ADDENDUM & CORRIGENDUM NO. 01**Dated: July 2, 2024****CONSTRUCTION OF SBP NEW OFFICE BUILDING AT GUJRANWALA**

In order to provide necessary clarification to facilitate the prospective bidders, this Addendum No.1 is issued, which shall be included in the Bidding Documents.

TYP. SECTION OF DOOR FRAME
(4"-TH. WALL)

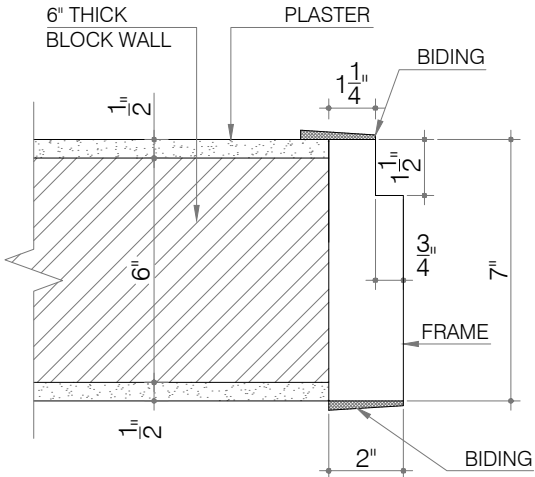
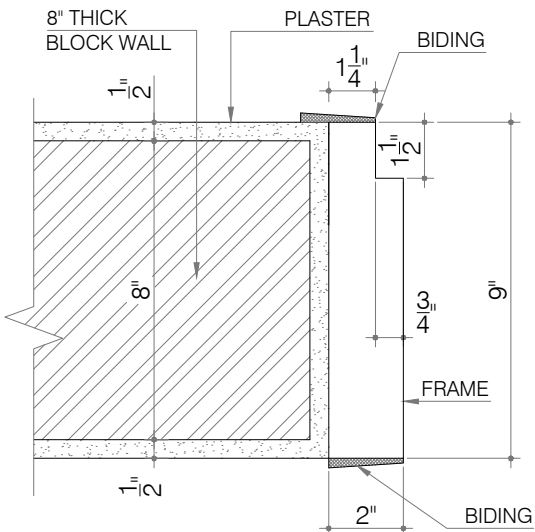
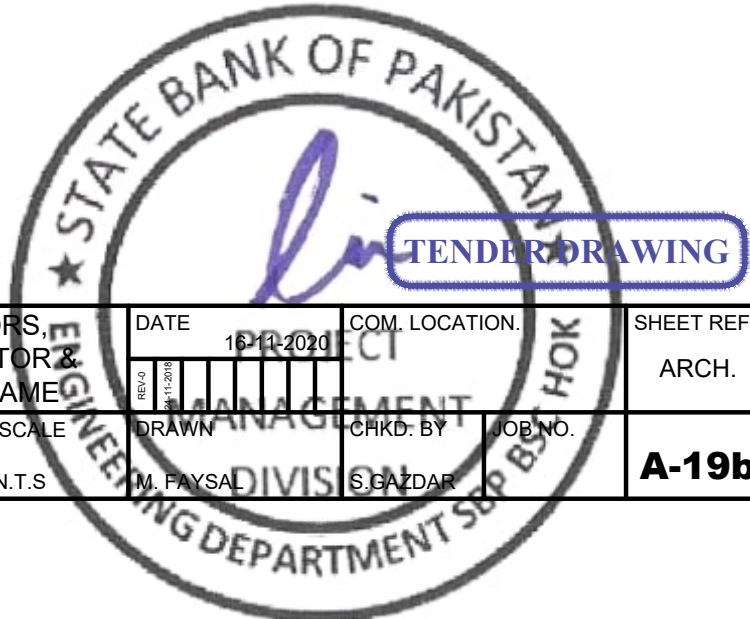
Sr #	Description / Reference / Clarifications Sought by Bidders / Corrections	<u>ADDENDUM</u>
22.	Volume – IV Bill of Quantities Operation & Maintenance Services, Item O&M 1-12 Volume-IIIC Operation and Maintenance Services Of Electrical, Mechanical & HVAC Works	In Days column “546” shall be replaced by “365” “546 Days” shall be replaced by “365 Days”
23.	BOQ Item of wooden doors Provide details of Chowkat/door frames	Drawing is attached as Annexure-B (Dwg# A-19b)
